APPLICANT : CEMEX (ROI) LTD

**WL0254-01 - Article 16(1)
Further Information Response
- Walshestown Co. Kildare**

ARTICLE 16(1) RESPONSE

Figure 8.15 Typical section through base and slope lining system

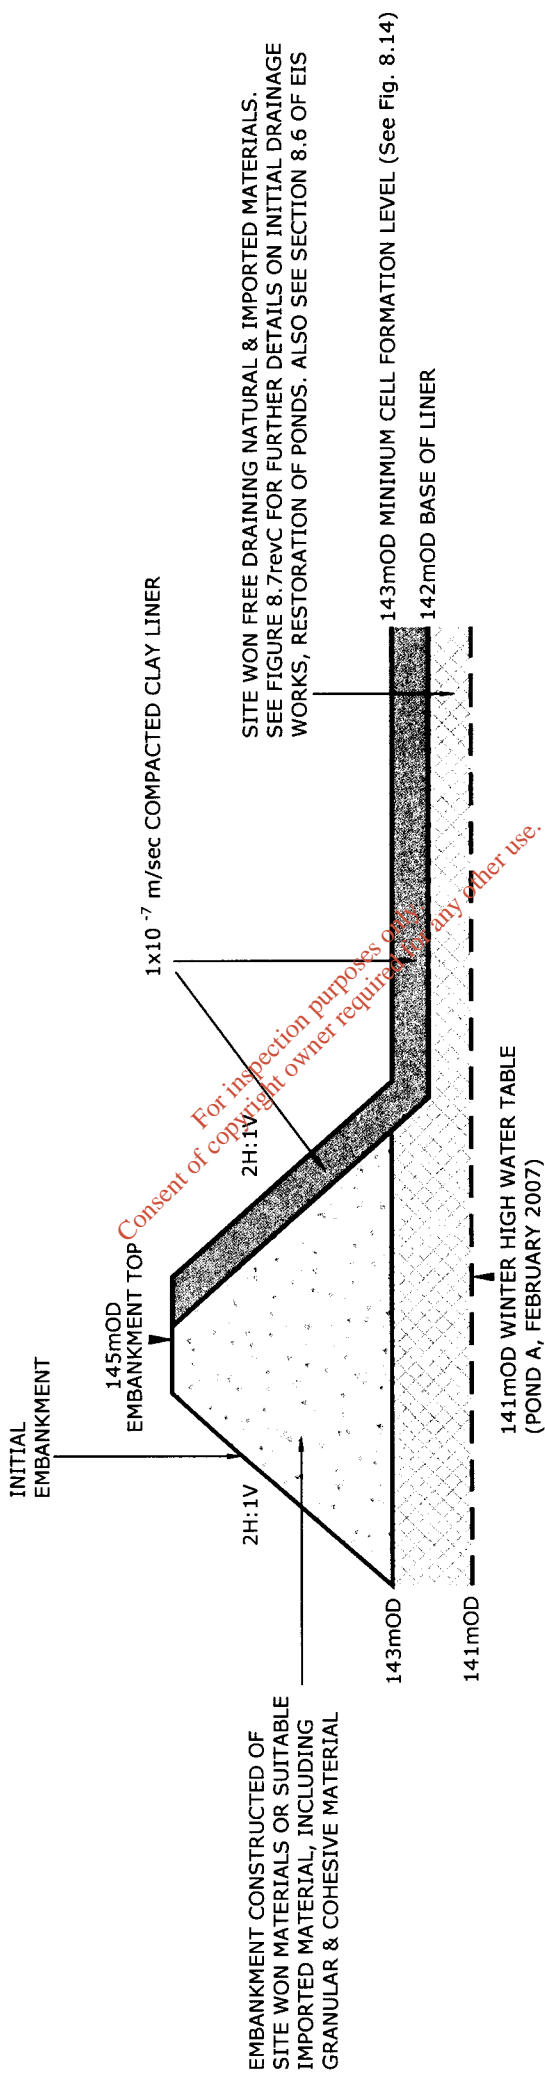
"Provide drawings showing the design of the landfill liner. Provide the specification for the liner, including a liner proposed to be placed in the area of ponds A1, A2 and A3".

Additional information on the liner specification is provided on Figure 8.15, **Appendix 7**, which depicts a typical section through the proposed base and slope lining system.

Figure 8.12 Rev. C Cross sections of new water feature

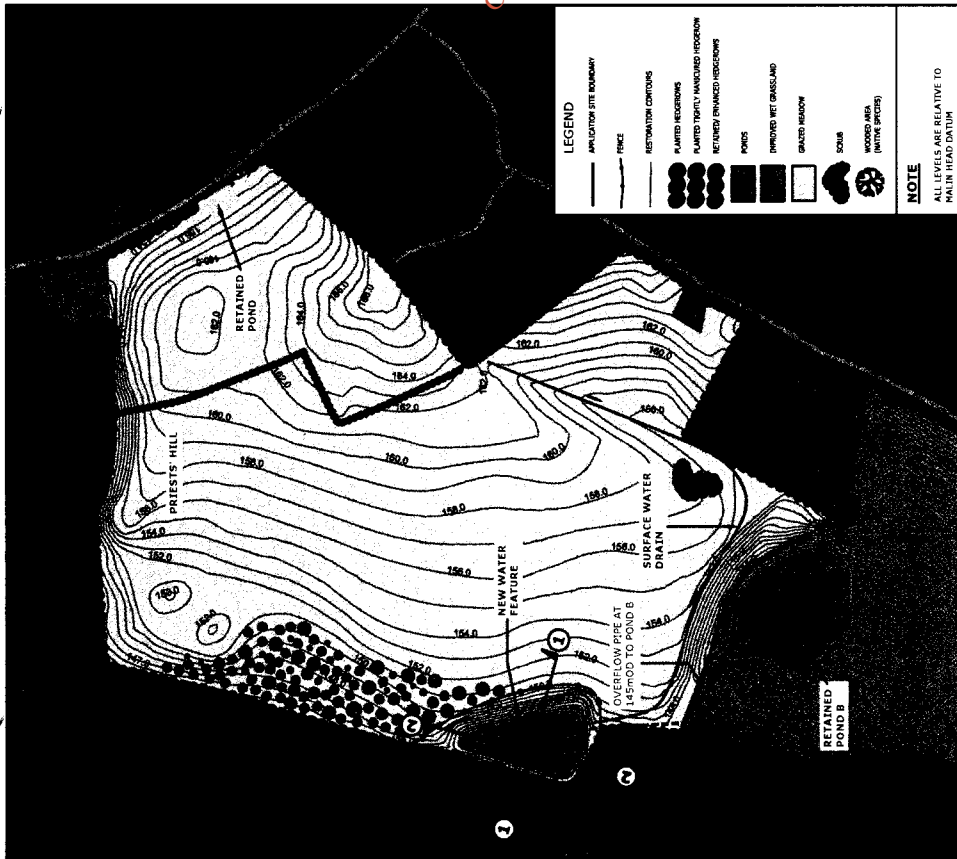
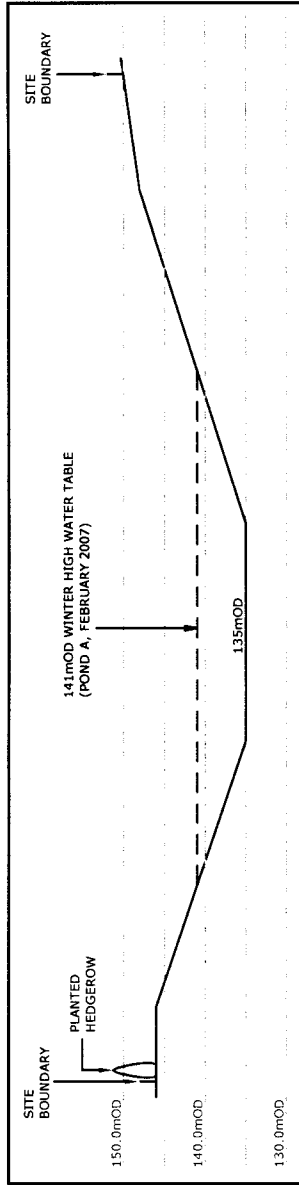
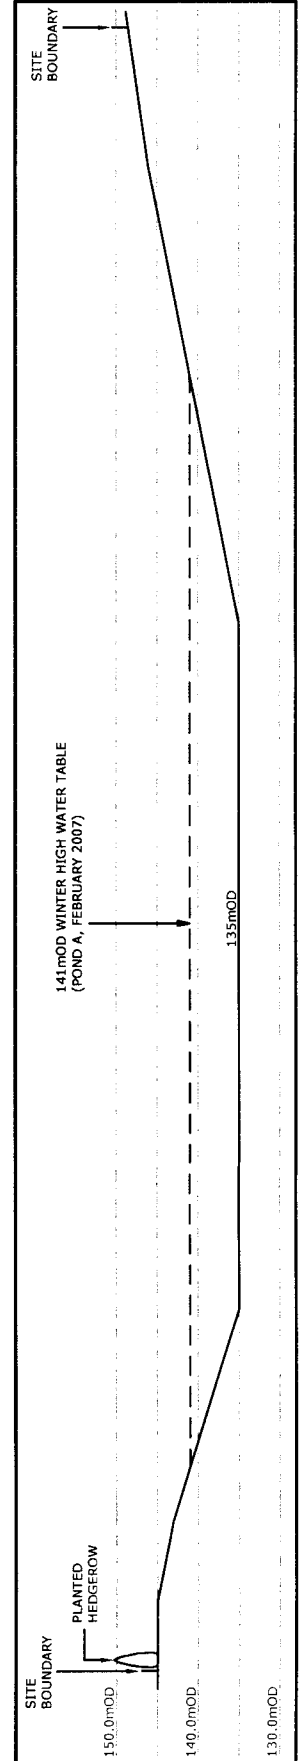
"Provide details of the construction of the New Water Feature. Provide a drawing showing cross section(s) through this feature. Describe the manner in which water pumped from ponds A1, A2 and A3 will discharge / percolate to ground from the New Water Feature."

Storm water will be accommodated in the New Water Feature on the western boundary where further capacity to infiltrate to ground will occur through the base and sides, collecting surface water from Catchment Area I (Figure 8.3 Rev. B). In the event of an extreme rainfall event, the proposed contingency overflow pipe will be in place at an elevation of ca. 145 mAOD, which will discharge any surplus waters, only at the very peak of the hydrograph, into the New Water Feature to Pond B (Figure 8.12, **Appendix 9**).

Figure 8.3 Rev. B - Final restoration and drainage plan

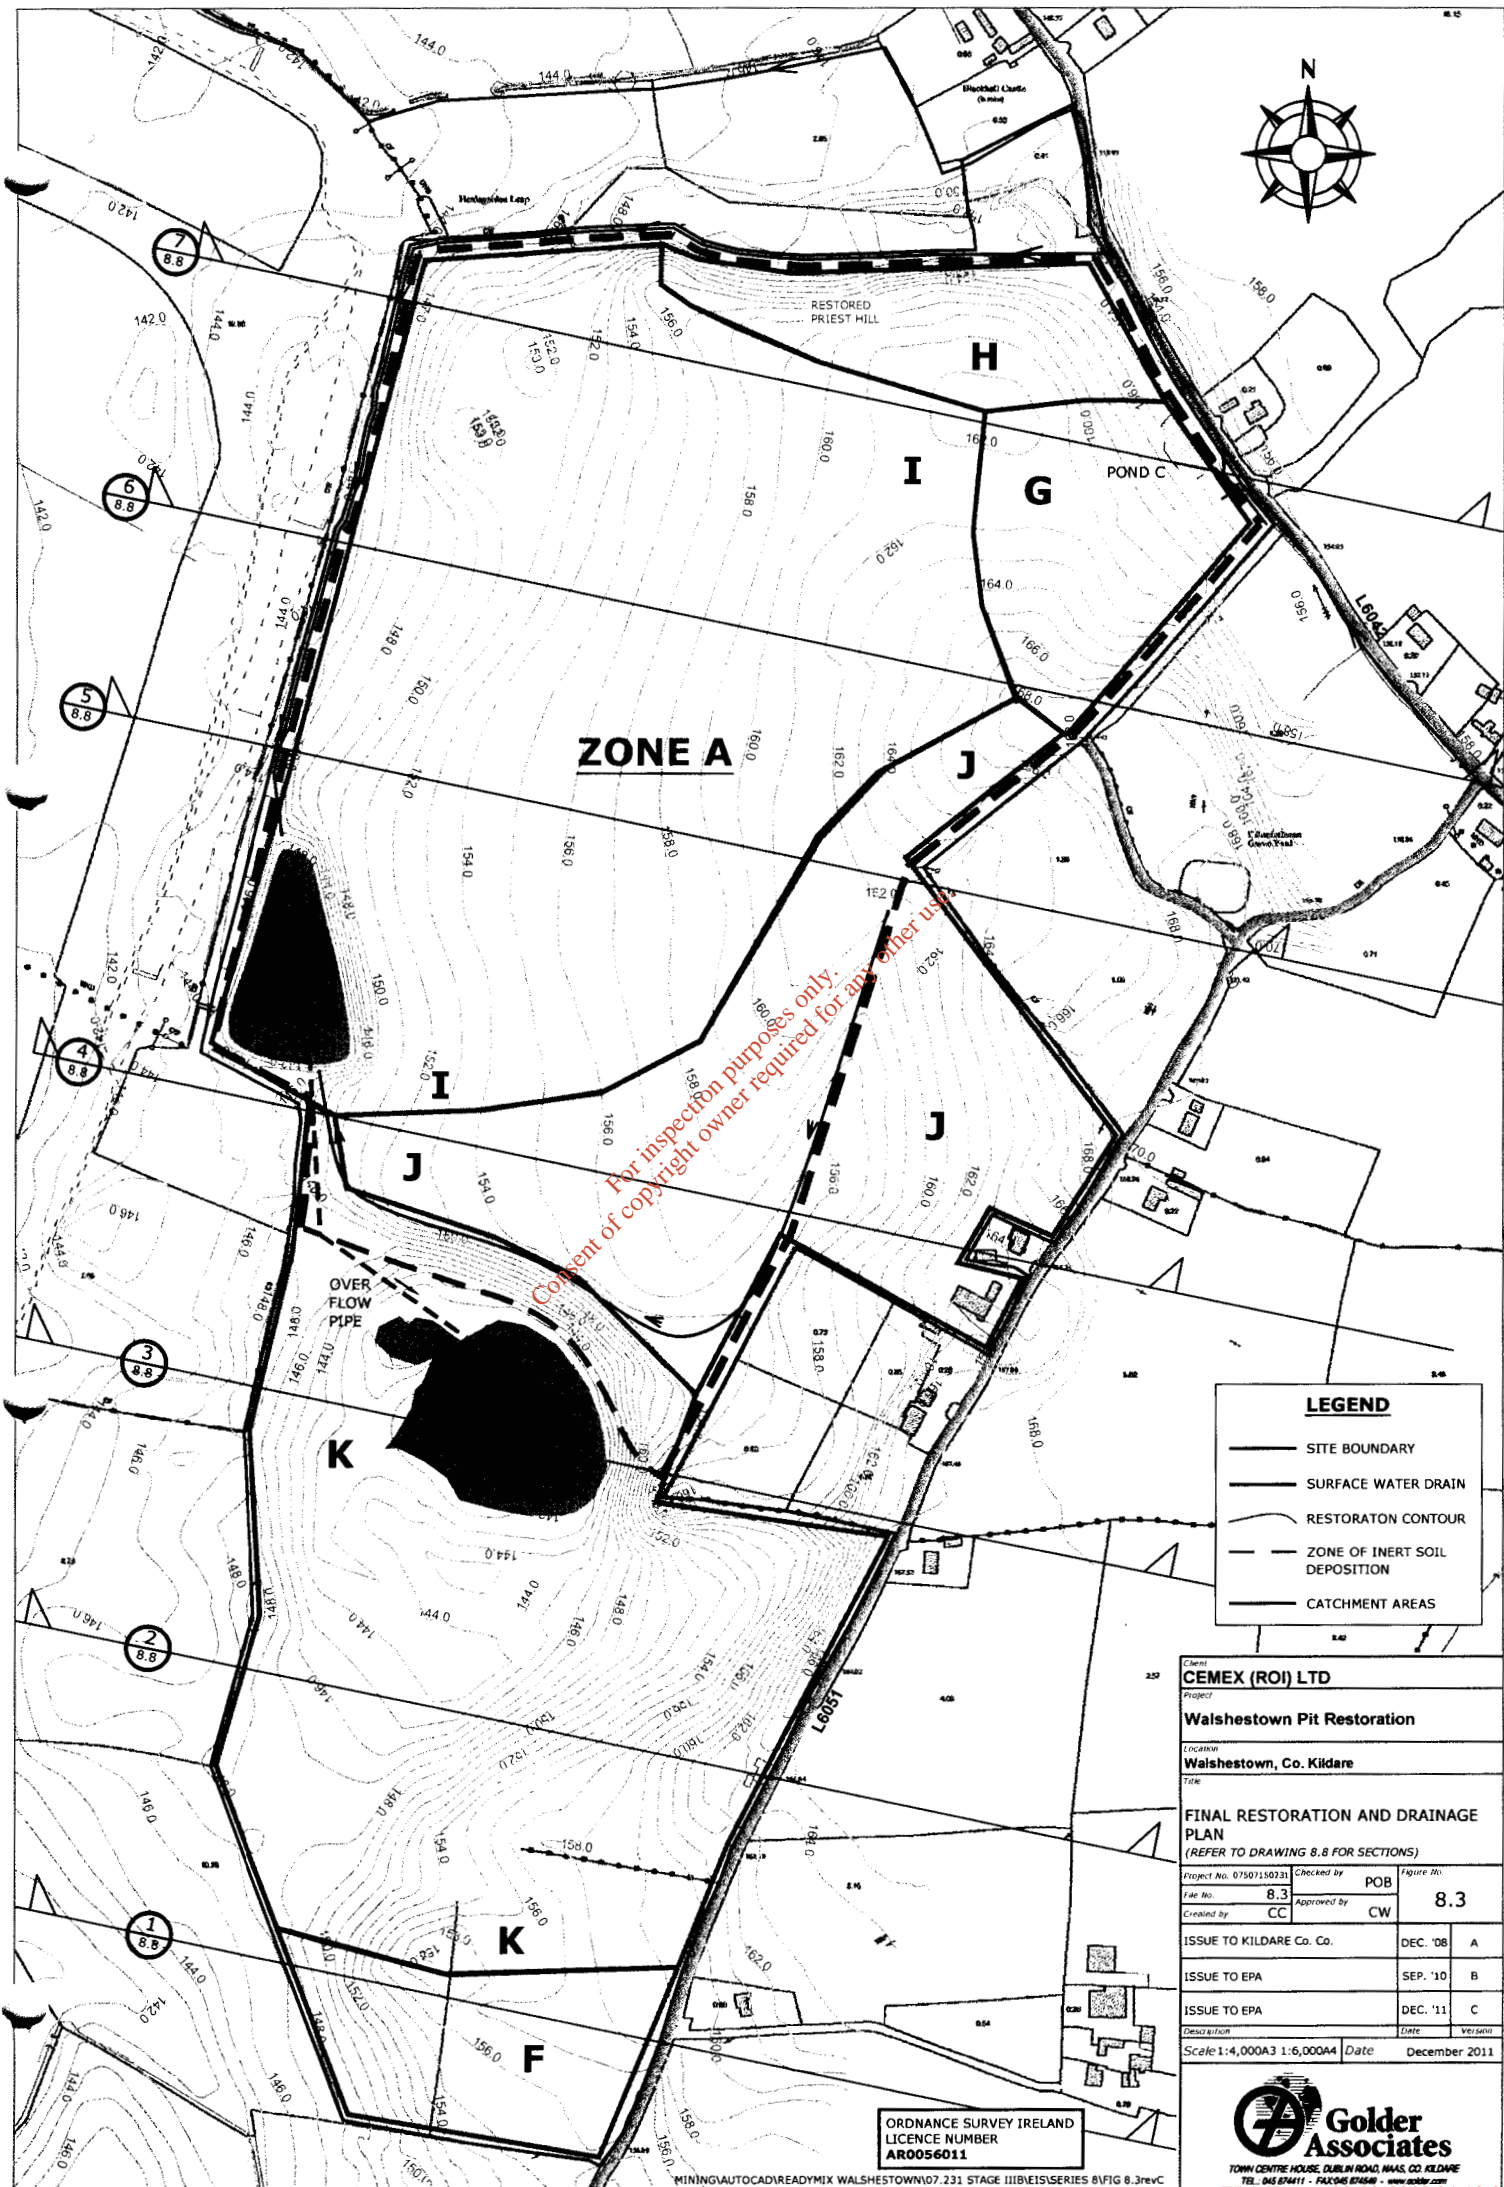
The final restoration surface contours are shown on Figure 8.3 Rev. B, **Appendix 10**. These have been designed, and will be constructed, in such a way that rainfall will shed to the perimeter infiltration trench. The resulting surface water catchments are also shown on Figure 8.3, and their size, a description of their ground surface, and their discharge outlets, are given in Table 2 below.
